Queenslanders with Disability Network response:

ARA Version of Disability Standards for Accessible Public Transport

Figure 1X-X

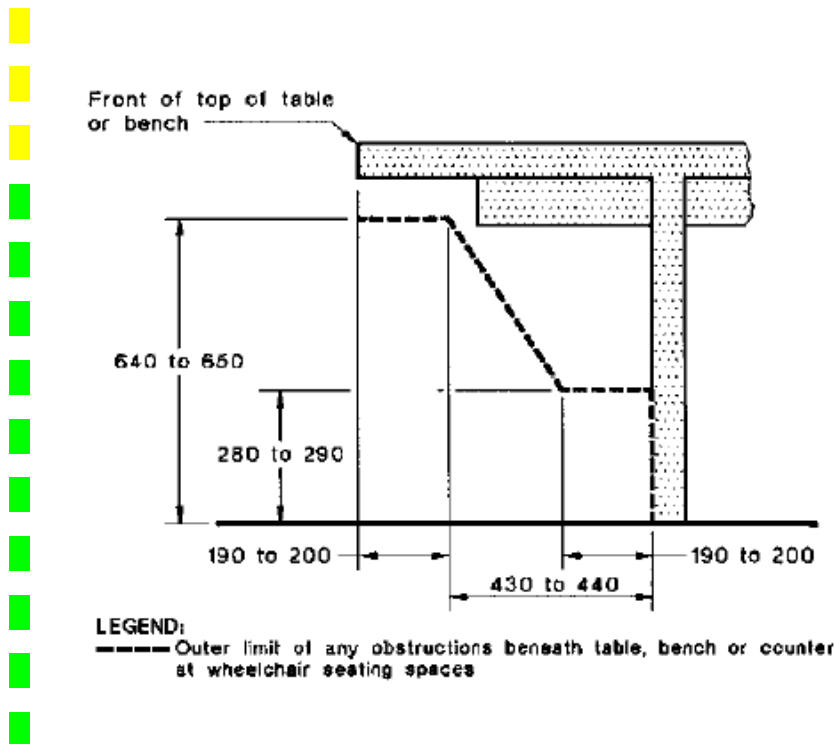
Disagree. As scooters are mobility aids in 1.19AX above this is an impossible requirement. Scooters have a wheel or wheels and steering column forward, while walking frames have framework forward. The above could only apply to wheelchairs.

FIGURE 4.3 STAIRWAY RISES AND GOINGS

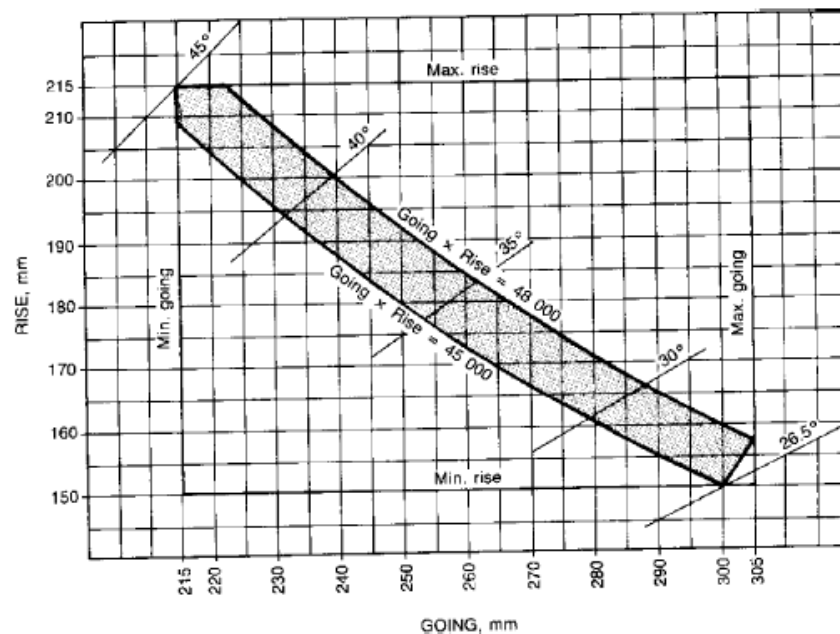
Disagree. Internal stairs may form part of an access path for people who are vision impaired but not mobility impaired. Minimum width of 850 mm has been lost, as has the dimensions of the treads and risers of internal stairs. AS1657 Figure 4.3 permits risers of up to 215 mm on entrance steps while AS1428.2 limits risers to 165 mm. This significantly increases difficulty of access for people who would otherwise use stairs and necessitates direct assistance or equivalent access.

FIGURE 23 POSITION OF WASHBASIN AND FIXTURES, AND OUTER LIMIT OF OBSTRUCTIONS BENEATH THE WASHBASIN

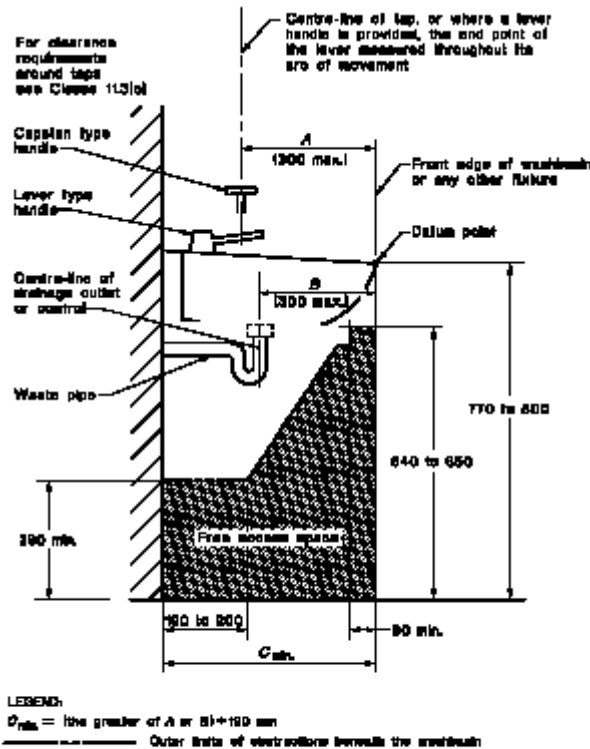
Internal width of rollingstock precludes compliance with this standard for the toilet door width, internal dimensions, and provision of a compliant access path past the toilet.

Accept. However, toilets and accessways fully compliant with AS1428.1 are installed on Brisbane City Council 'Citycat' ferries. Since compliance can be achieved on one of the modes listed, it may be best to use the unjustifiable hardship clauses to cover any non-compliance on the other.

FIGURE 23X TYPICAL PARK BENCH SEATING – Recommended dimensions

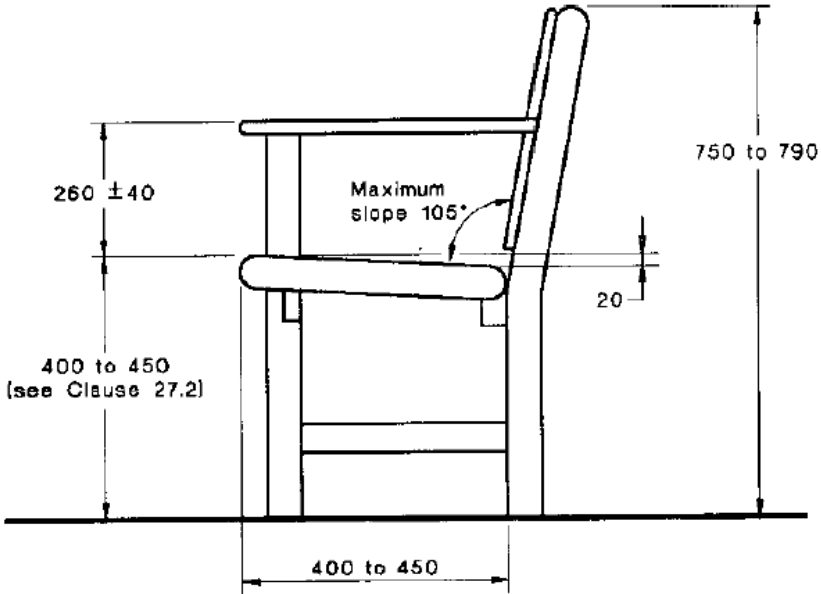
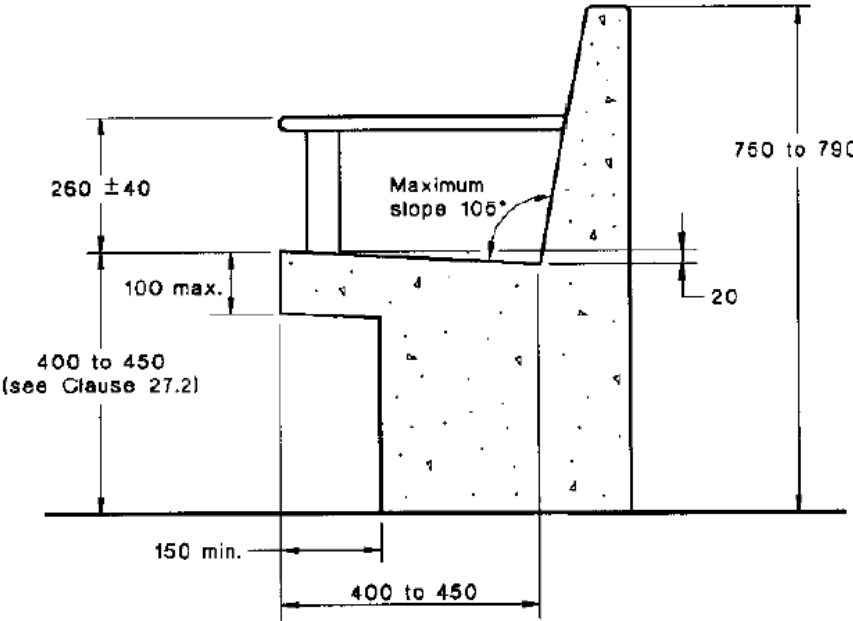
The design and installation of seating shall be as Figure 23X and recommended dimensions as follows:

FIGURE 24X BARRIERS WITH TICKET OR COIN FEED POINTS

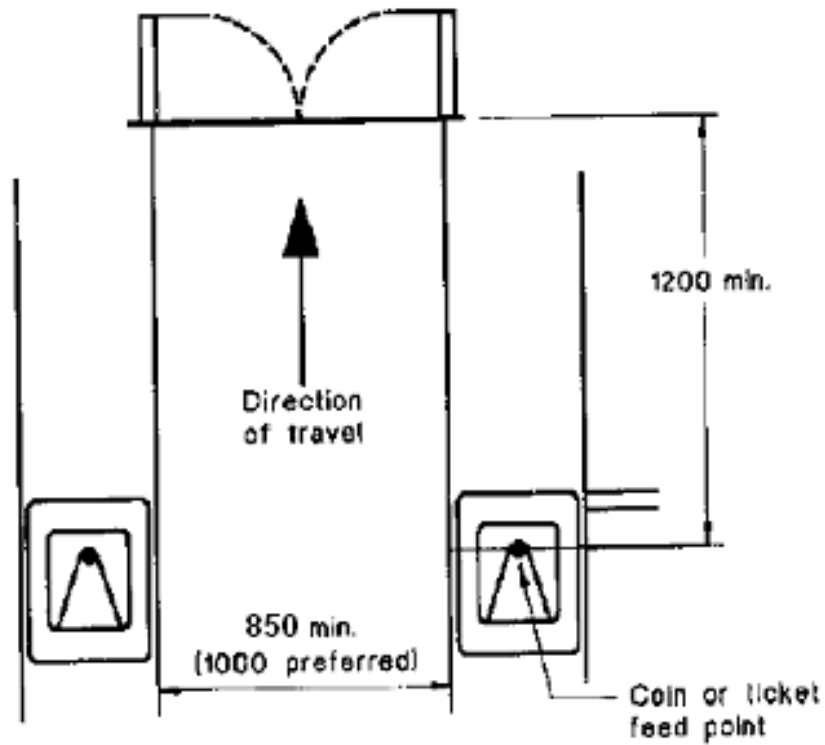
Disagree. Telephones in AS1428.2 Figure 35 have 1100 mm as maximum height and 850 mm \pm 20 mm as the minimum height for operable parts, not the 1200 mm - 500 mm required for vending machines in AS1428.2 Clause 29.1. Part 24.1 of the Transport Standard refers directly to Gateways and Checkouts. It is best to use the directly relevant Clause from AS1428.2 (Clause 28) rather than extrapolating from vending machine or telephone requirements.
